Page 1 of 8 SB412-7042 Rev A

SB412-7042; Bell 412 Air Conditioner System

Condenser Frame Modification.

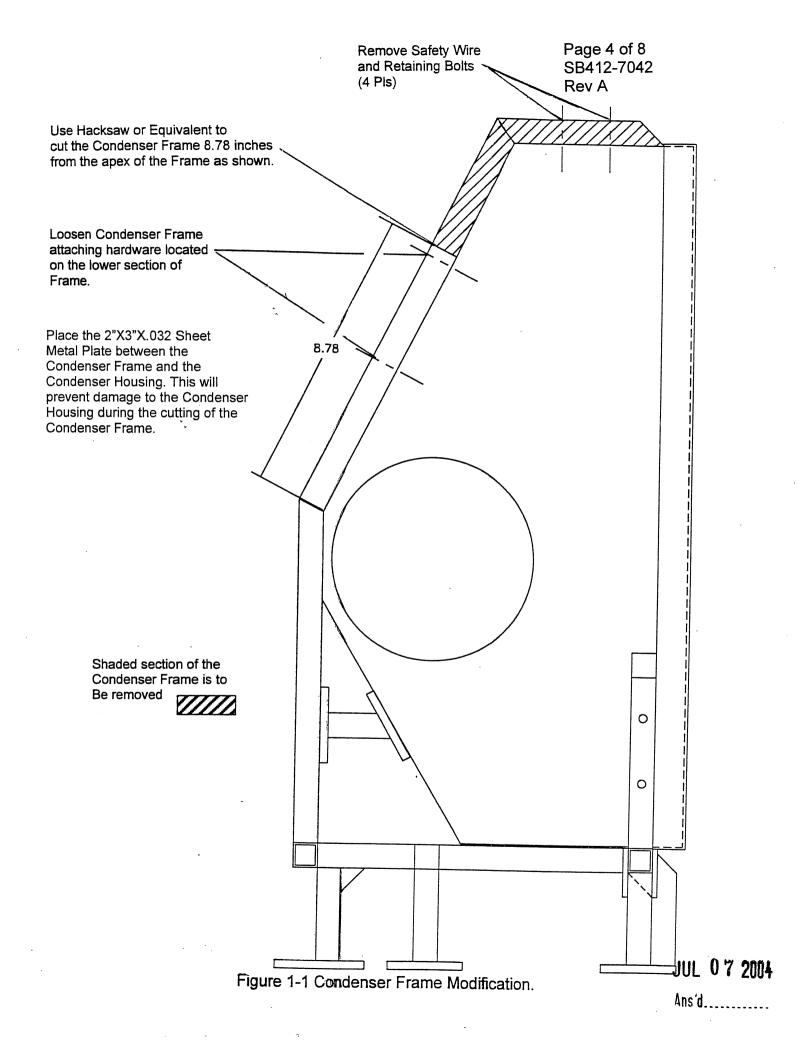
- 1. Remove the upper, and lower forward sections of the Transmission Cowlings from the cabin roof to gain access to the Condenser and Condenser Frame assembly.
- 2. Remove safety wire from the four (4) Condenser Frame mounting bolts located in the top of the Condenser Assembly. Remove and discard the mounting bolts. (See figures 1-1 & 1-2)

Figure 1-3 Condenser Frame Modification (Serial Numbers 36130, 36132, & 36134 only)

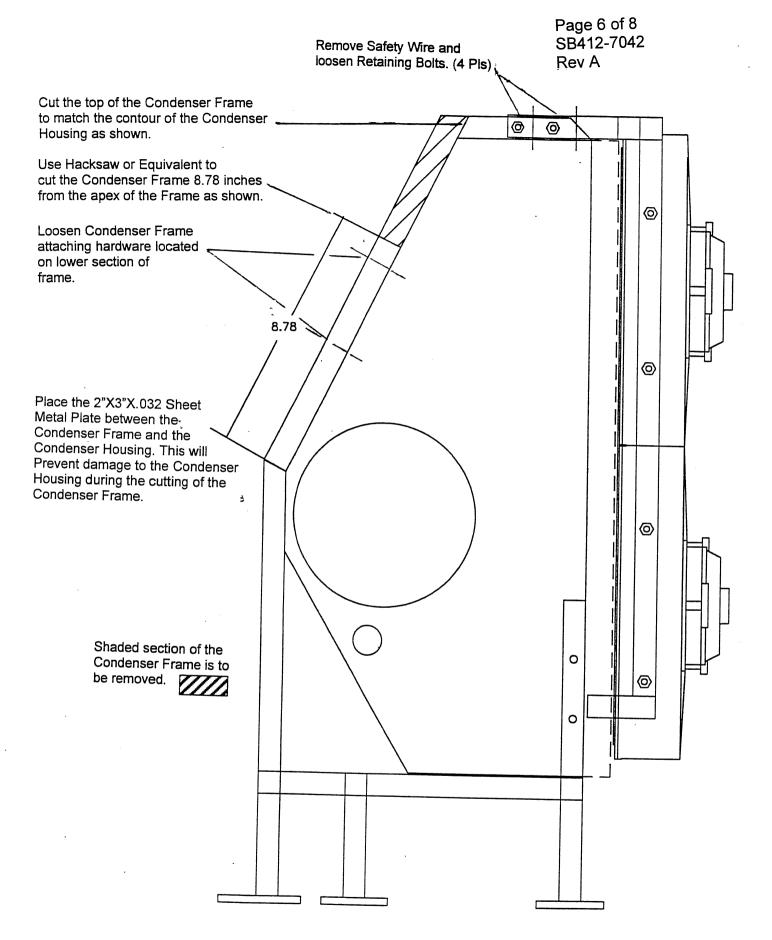
For Serial Numbers 36130, 36132, & 36134 loosen the mounting bolts located in the top of the Condenser Frame. Removal is not required for these three aircraft. (See figures 1-3 & 1-4)

For Serial Numbers 36130, 36132, & 36134, it will be necessary to make additional cuts at the top aft section of the Condenser Frame Assembly. (See figures 1-3 & 1-4).

For Serial Numbers 36130, 36132, & 36134, replacement of bolts in top of Condenser Housing is not required. Re-torque existing Bolts 50 –60 inch lbs., and safety wire using .032 Safety Wire.

Figure 1-5 Condenser Frame Modification (For Condensers not equipped with existing internal mounting brackets to accommodate attaching hardware of condenser frame.)

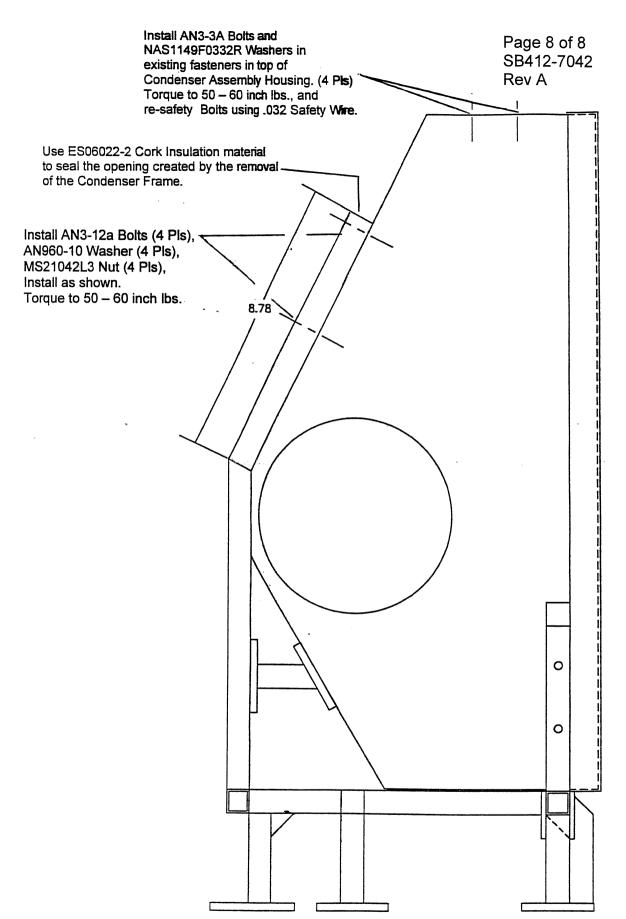
Item	Part Number	Description	Qty.
1	AN3-3A	Bolt	4
2	NAS1149F0332R	Washer	4
3	ES06022-2	Cork Insulation	4"
4	-	2"X3"X.032 Sheet Metal Plate	1
5	AN3-12A	Bolt (Fig 1-5)	4
6	AN960-10	Washer (Fig 1-5)	4
7	MS21042L3	Nut (Fig 1-5)	4
